TECHNICAL BULLETIN

TB-0174

Criteria for pole reinstatements

Annexure 1 – Assessment of Serviceability Flowchart (Figure #2)

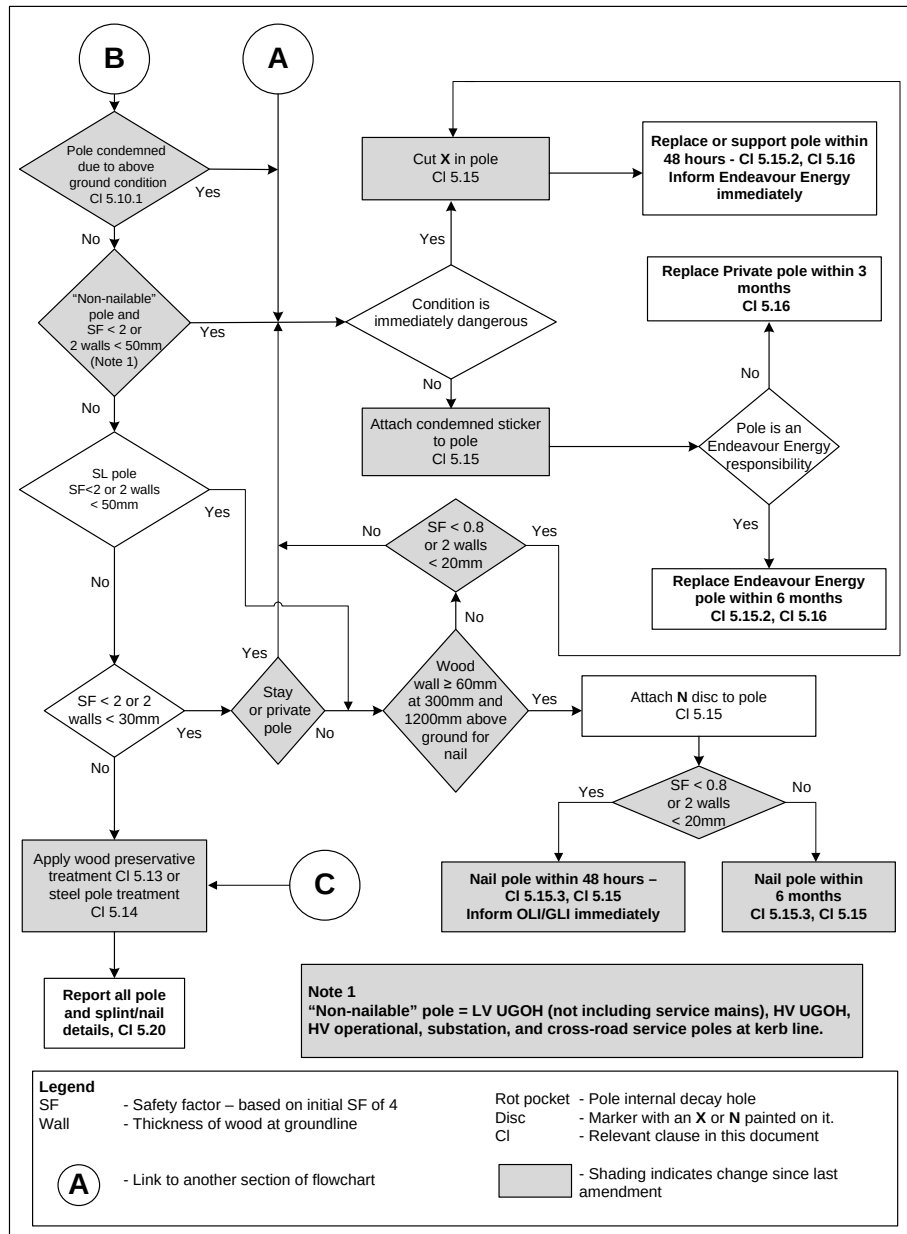
The revised *Assessment of Serviceability Flowchart* can be found in **Annexure 1**.

All wood poles (eligible for nailing) once inspected and found to be defective below ground shall be firstly considered for pole nailing before replacement. This applies to all defect priority categories including 48 hours, 2 months and 6 months as well as poles that may have been condemned by other means than pole interior assessment.

If the wall thickness of a defective pole at 300mm and 1200mm above ground is greater than 60mm, the pole shall be nailed, provided there are no termites, open knot holes, fungal spores, cracking or splitting.
